**AMENDMENTS TO THE DRAWINGS**

The application has been amended in accordance with the Notice of Draftsperson's Patent Drawing Review, dated February 9, 2006. More particularly, the modifications requested to figures 1, 2, and 5 have been made.

~~FIGURE 5~~

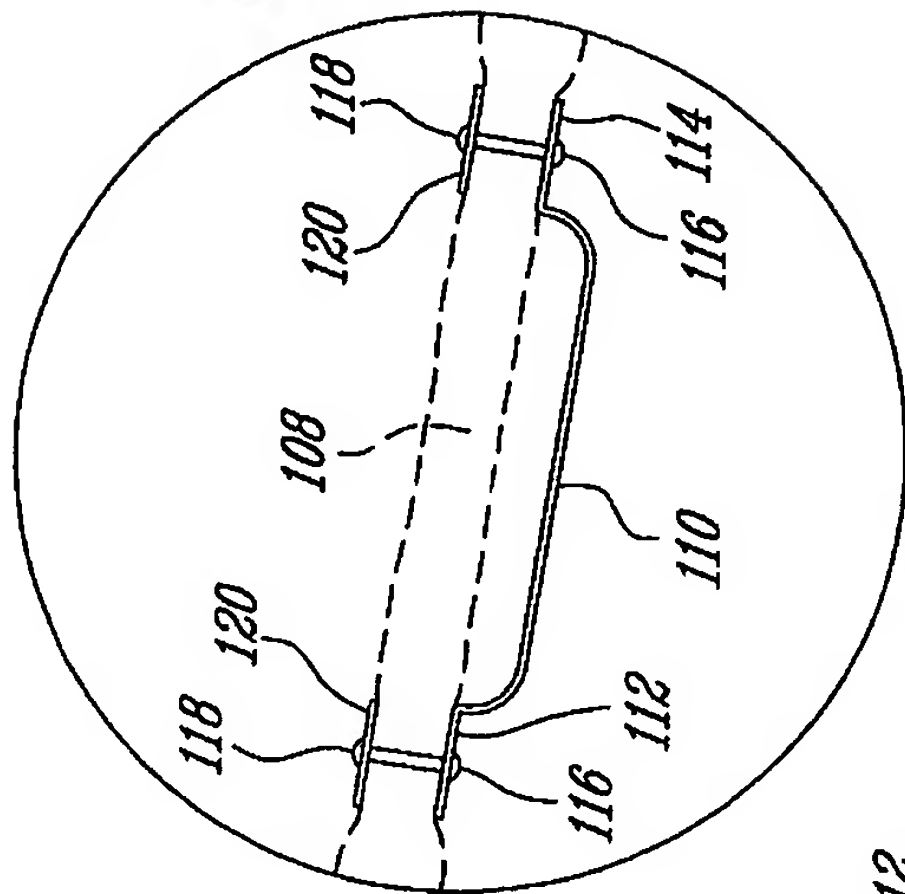
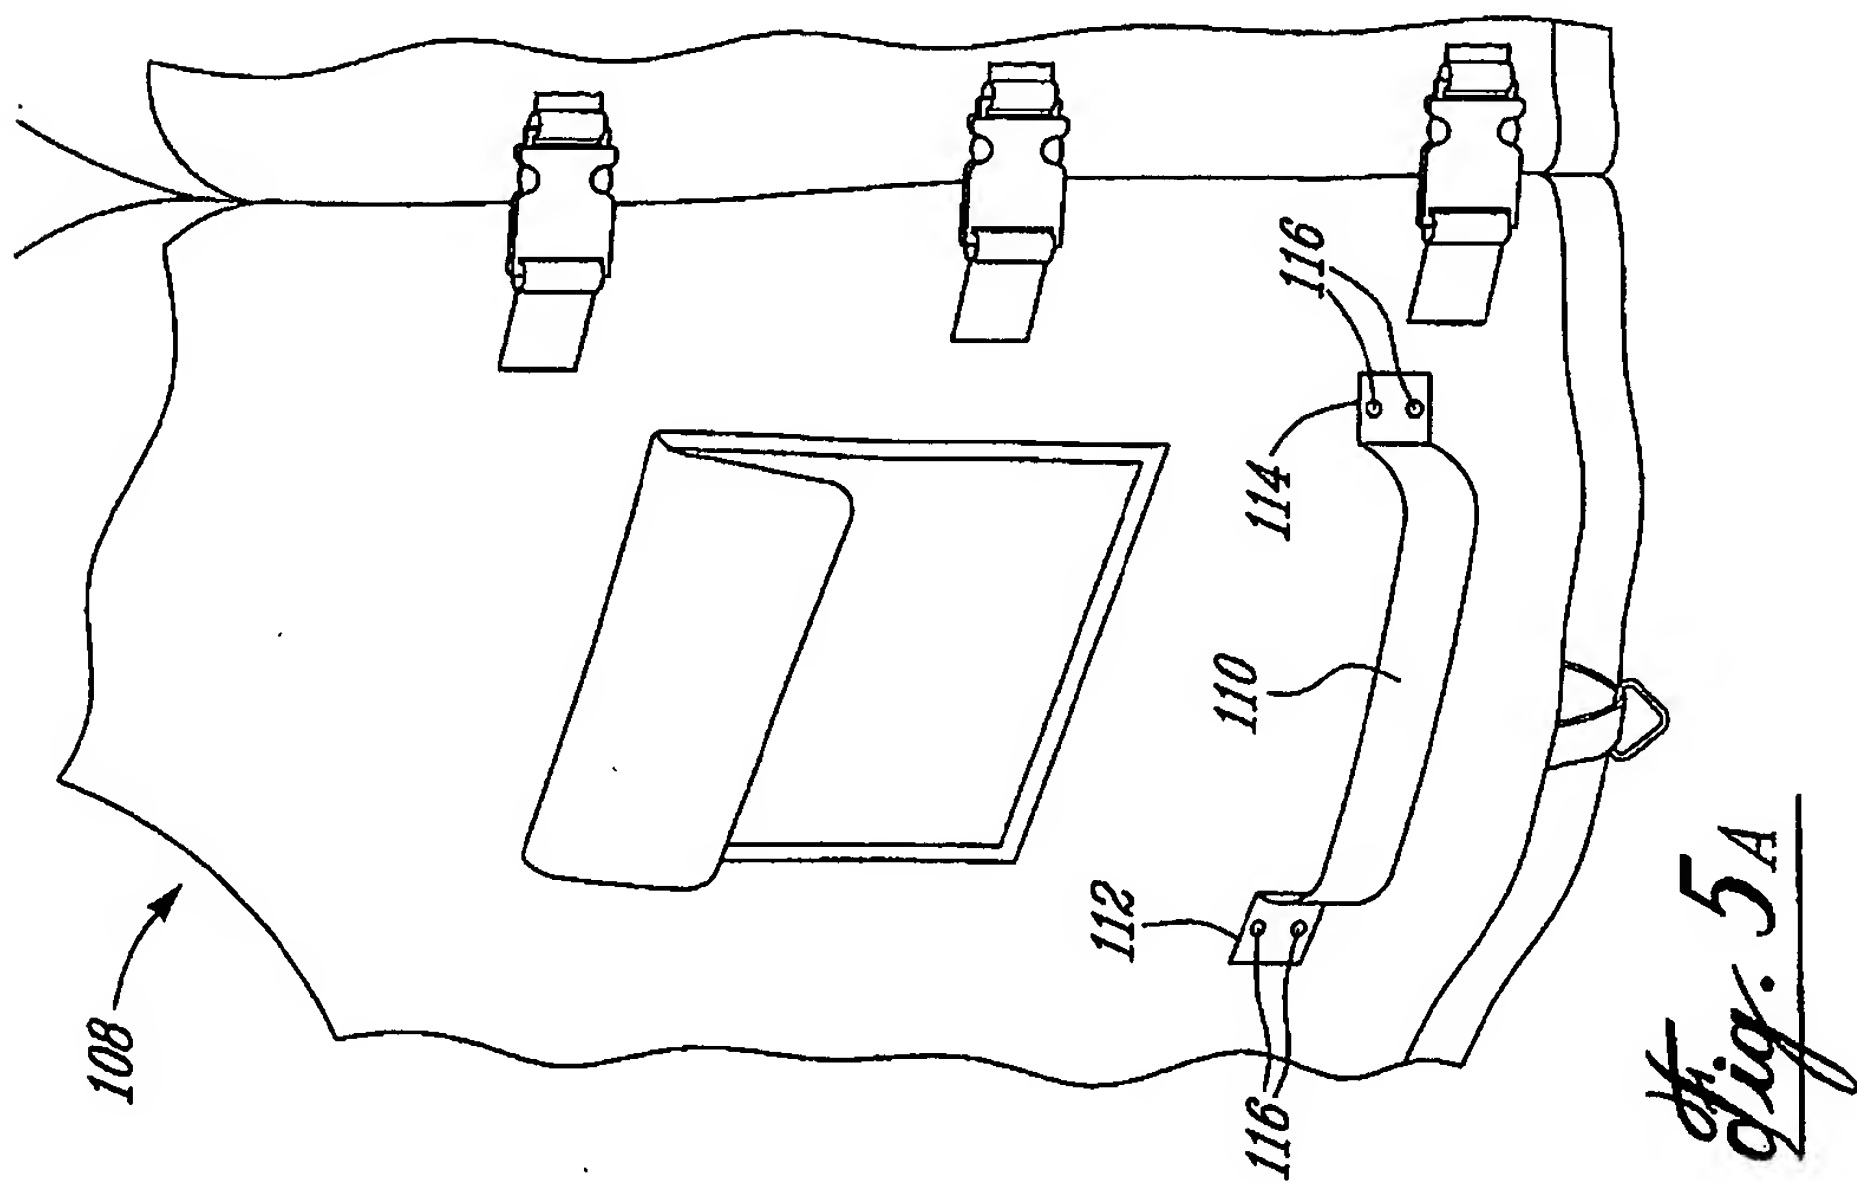
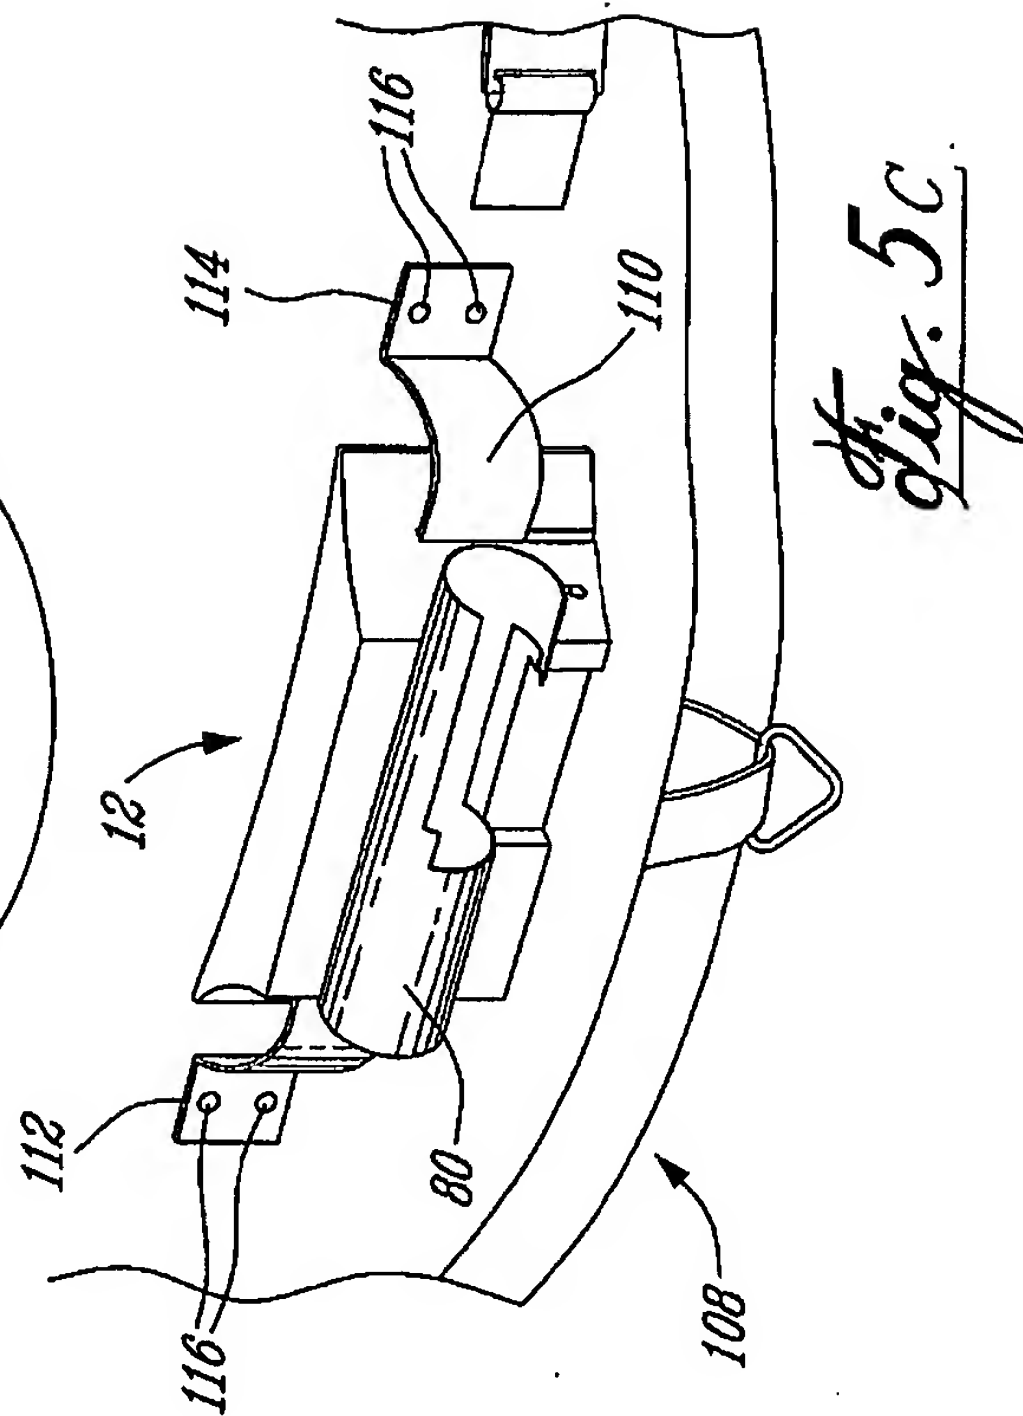
The figures 1, 2, 4, and 5 have been renumbered Fig. 1a, Fig. 1b, Fig. 1c, Fig. 2a, Fig. 2b, Fig. 4a, Fig. 4b, Fig. 5a, Fig. 5b, and Fig. 5c respectively.
